ACCESS TECHNICAL REVIEW – GULL SERVICE STATION, MOLESWORTH DRIVE, MANGAWHAI

Further to your instruction, we have undertaken a peer review of the access arrangement at the proposed Gull Station on Molesworth Drive in Mangawhai.

RE: Gull Mangawhai Access Arrangements, Safe System Assessment Framework

Site access.

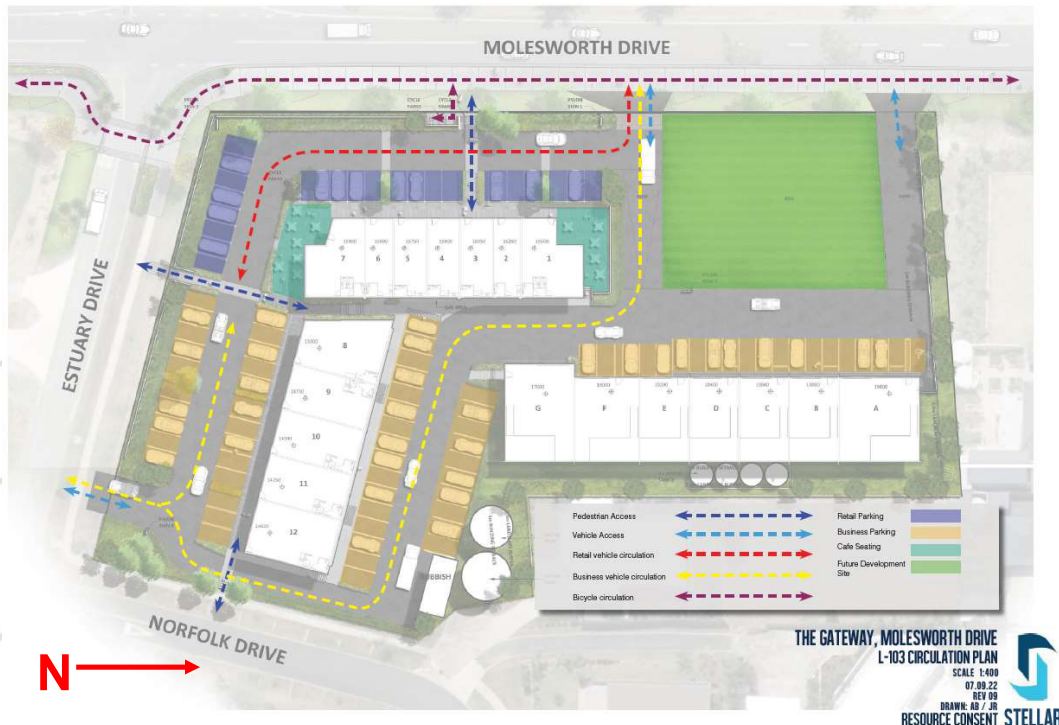
Lot 1 DP 341981 currently has an access off Molesworth Drive by means of a formed access at the north end of the subject site, there is a segregation strip for the remainder of the frontage with Molesworth Drive.

As indicated above the vehicle access is via three accesses, one off Estuary Drive and two accesses off Molesworth Drive. Of the two access off Molesworth Drive one will utilise the existing vehicle crossing which will be upgraded and one will be a newly created access. The more southerly access off Molesworth Drive and the access off Estuary Drive will be used by traffic in both directions. The more northerly access off Molesworth Drive will be used as an access only.
